CITY OF ALBUQUERQUE

Re: Bob's Burger Drive thru Restaurant
5307 4th street N.W. ALB NM 87107
Traffic Circulation Layout
Engineer's/Architect's Stamp **10-12-18 (F14-D036)**

The TCL submittal received 10-23-18 is approved for Building Permit. A copy of the stamped and signed plan will be needed for each of the building permit plans. Please keep the original to be used for certification of the site for final C.O. for Transportation.

AS-101

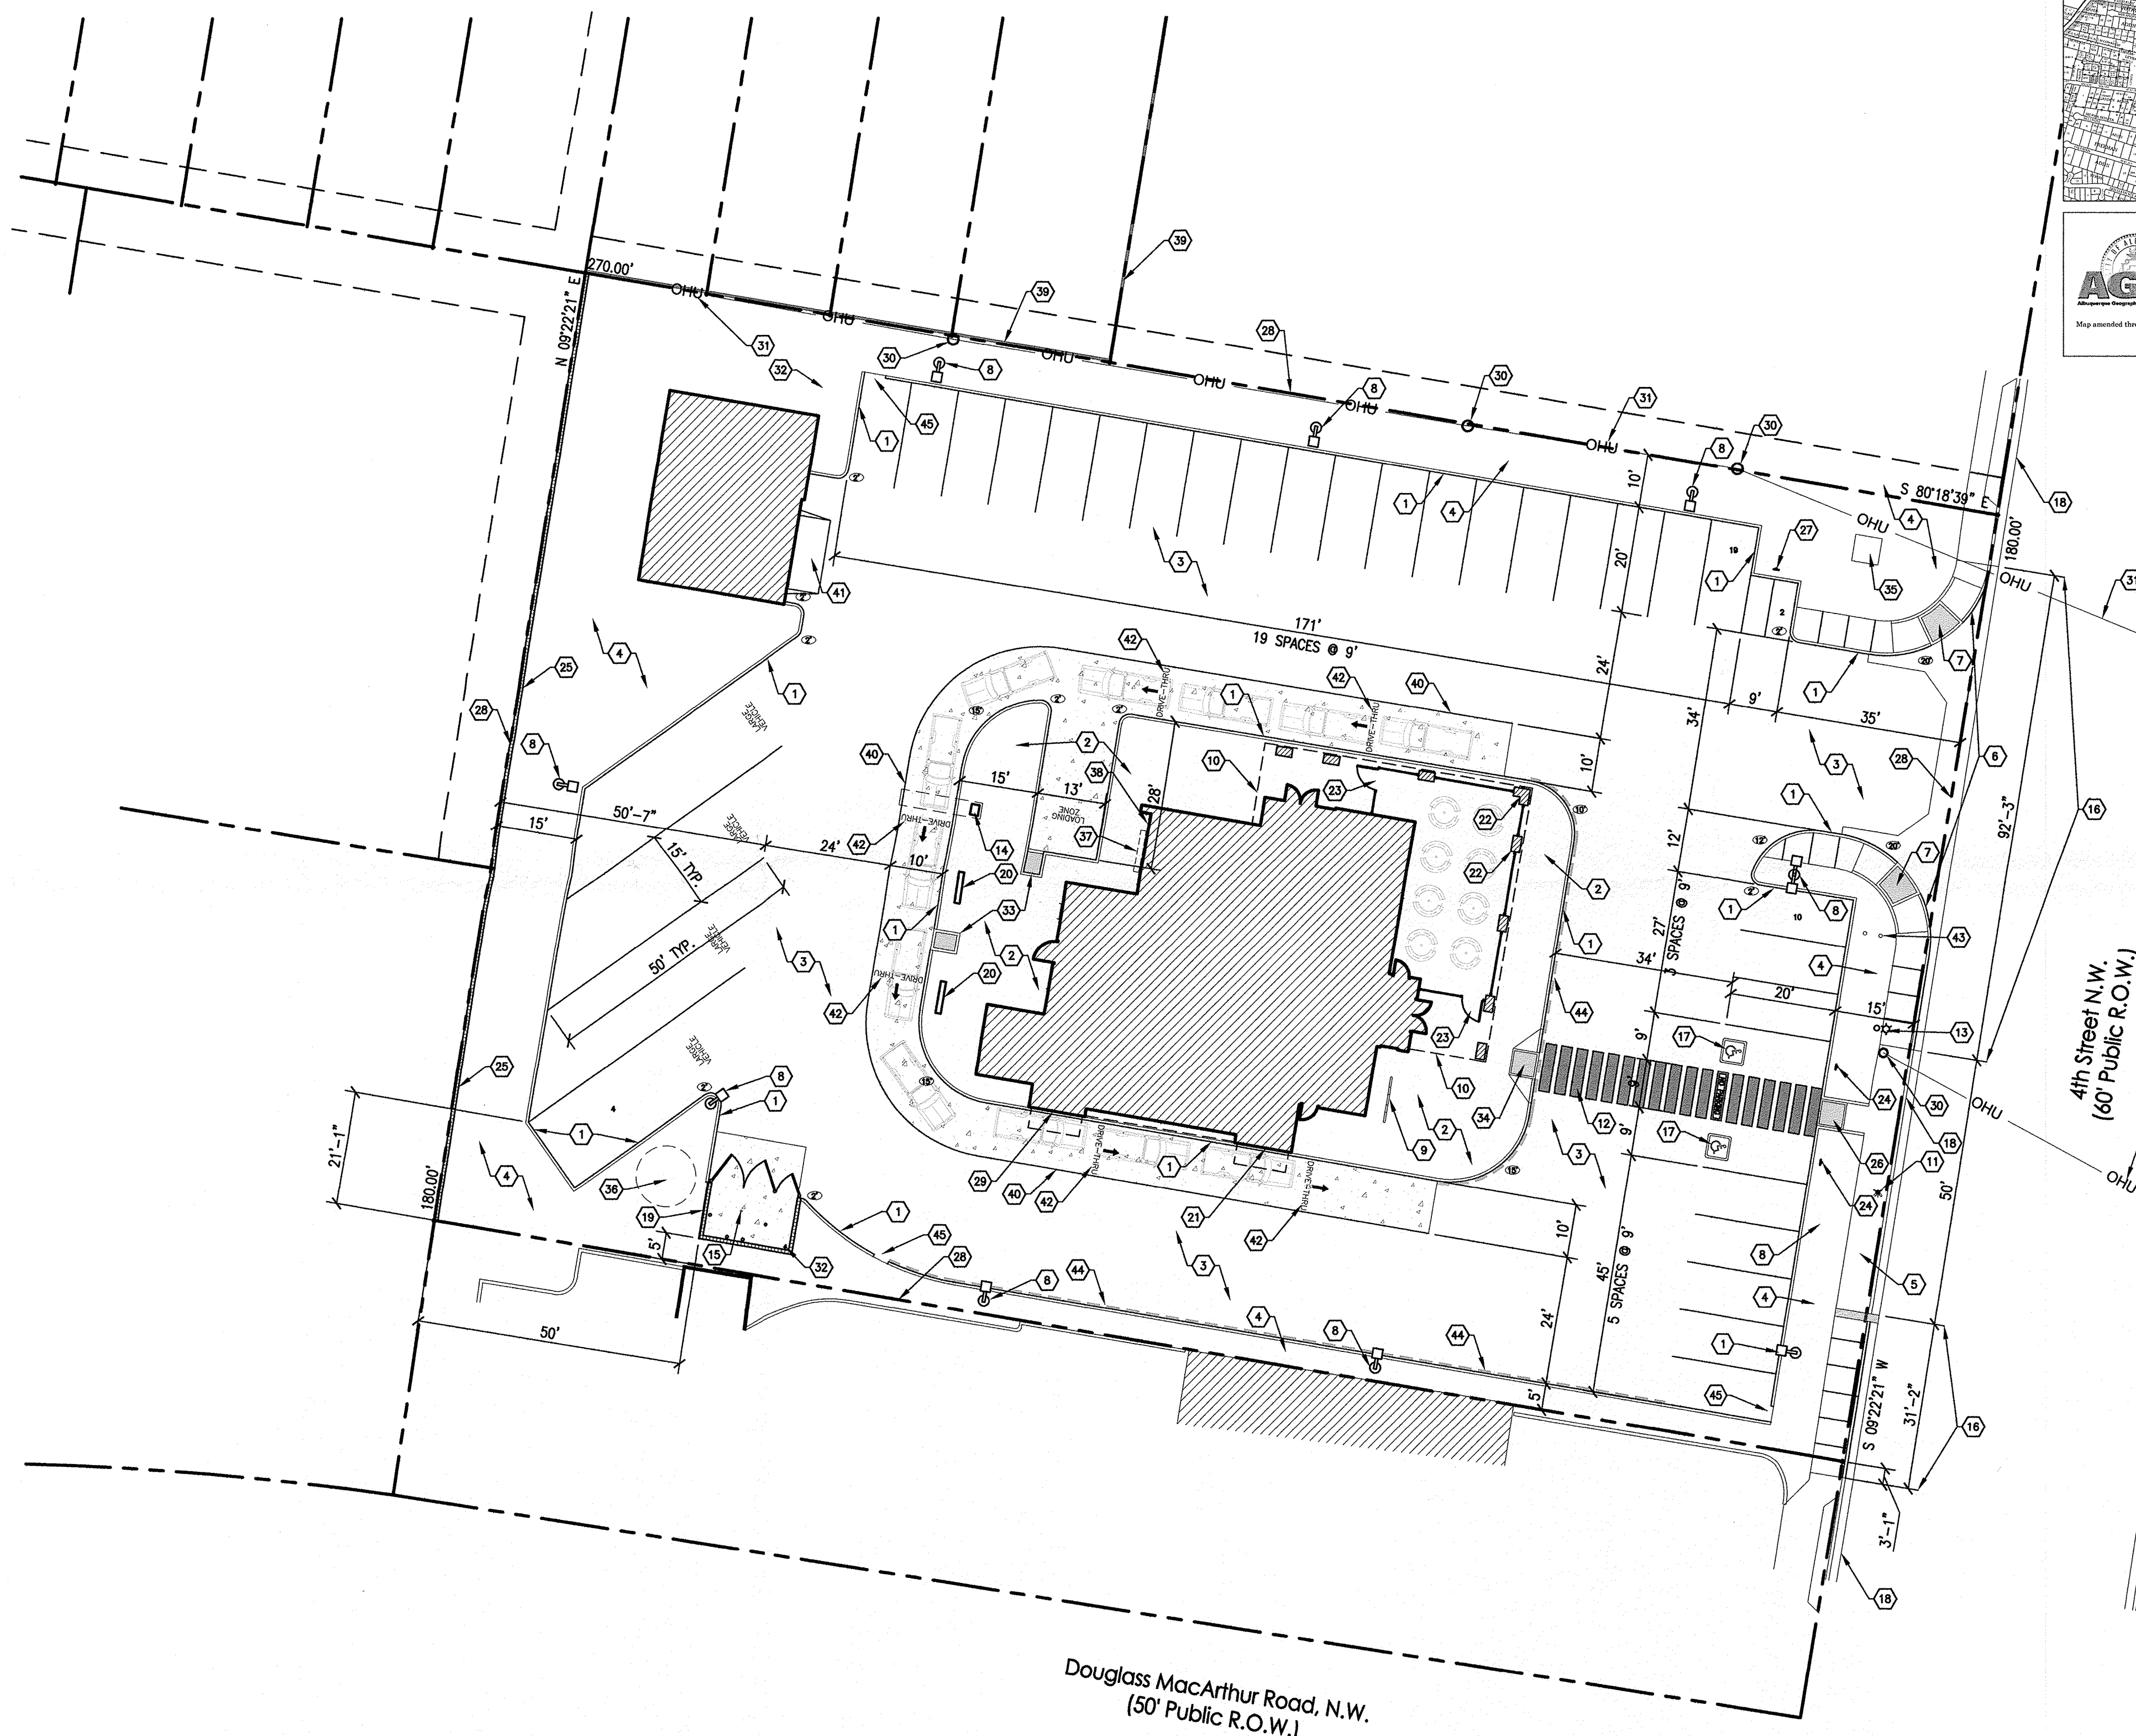
When the site construction is completed and a Certificate of Occupancy (C.O.) is requested, use the original City stamped approved TCL for certification. Redline any minor changes and adjustments that were made in the field. A NM registered architect or engineer must stamp, sign, and date the certification TCL along with indicating that the development was built in "substantial compliance" with the TCL. Submit this certification TCL with a completed Drainage and Transportation Information Sheet to front counter personnel for log in and evaluation by Transportation.
